**Inspection Report
6 Central Park Avenue, Chippendale**

Council Investigation Officer Inspection and Recommendation Report; Clause 17(2) Part 8 of Schedule 5 of the Environmental Planning and Assessment Act 1979 (the Act)

**RE: INSPECTION REPORT
IGLU STUDENT ACCOMMODATION
6 CENTRAL PARK AVENUE CHIPPENDALE ("the premises")**

Image 1 - quarter-turn isolation valves

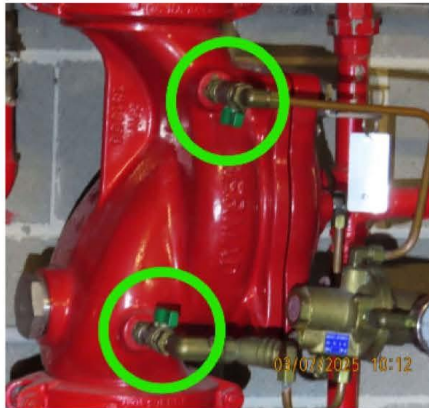
- e An egress door that does not permit occupants to evacuate the premises may place evacuees in an unsafe situation.
- f The PO-PRV installed within the combined sprinkler/hydrant pumproom and fire isolated stairways, incorporates quarter-turn isolation valves on the supply and sensing pipes for the pilot valve (Image 1 below).

- i. When turned to the 'OFF' position, the combined hydrant and sprinkler system will not operate as required. The complementary fire safety measures, such as occupant warning, zone smoke control and automatic fire brigade response will not automatically operate.

- ii. Clause 2.13 of AS2118.6-2012 requires fault monitoring of isolating valves either side of a pressure reduction valve.
- g As a result of a combined sprinkler and hydrant system not operating following a fire at a premises elsewhere, FRNSW released a position statement, [Pilot operated pressure reduction valve \(PO-PRV\) installation](#).

1. Restore the Smoke Detection and Alarm Systems (SDAS) by removing all faults and isolations associated with the system.
2. Repair the egress doors within the building to open without undue force.
3. Rectify the Pilot Operated Pressure Reduction Valves (PO-PRV) to prevent isolation of the firefighting system by either,
 - a. Removing the quarter-turn isolating valve from the pilot sensing and supply pipe, or
 - b. Locking in the open position and monitoring the quarter-turn isolating valve in accordance with the relevant Australian Standard, or

- c. Replacing the POPRV with a pressure reducing valve that does not have any isolating valve on the pilot tube.

Image 1 - quarter-turn isolation valves

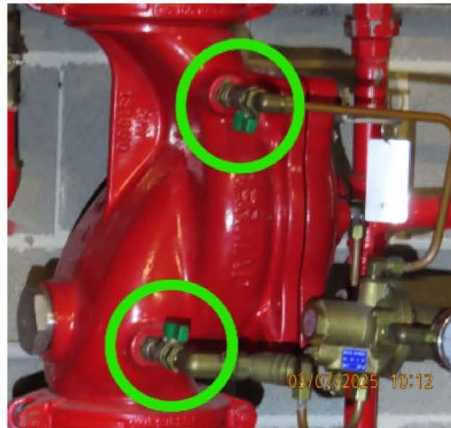
- e An egress door that does not permit occupants to evacuate the premises may place evacuees in an unsafe situation.
- f The PO-PRV installed within the combined sprinkler/hydrant pumproom and fire isolated stairways, incorporates quarter-turn isolation valves on the supply and sensing pipes for the pilot valve (Image 1 below).

- i. When turned to the 'OFF' position, the combined hydrant and sprinkler system will not operate as required. The complementary fire safety measures, such as occupant warning, zone smoke control and automatic fire brigade response will not automatically operate.

- ii. Clause 2.13 of AS2118.6-2012 requires fault monitoring of isolating valves either side of a pressure reduction valve.
- g As a result of a combined sprinkler and hydrant system not operating following a fire at a premises elsewhere, FRNSW released a position statement, [Pilot operated pressure reduction valve \(PO-PRV\) installation](#).

1. Restore the Smoke Detection and Alarm Systems (SDAS) by removing all faults and isolations associated with the system.
2. Repair the egress doors within the building to open without undue force.
3. Rectify the Pilot Operated Pressure Reduction Valves (PO-PRV) to prevent isolation of the firefighting system by either,
 - a. Removing the quarter-turn isolating valve from the pilot sensing and supply pipe, or
 - b. Locking in the open position and monitoring the quarter-turn isolating valve in accordance with the relevant Australian Standard, or

- c. Replacing the POPRV with a pressure reducing valve that does not have any isolating valve on the pilot tube.
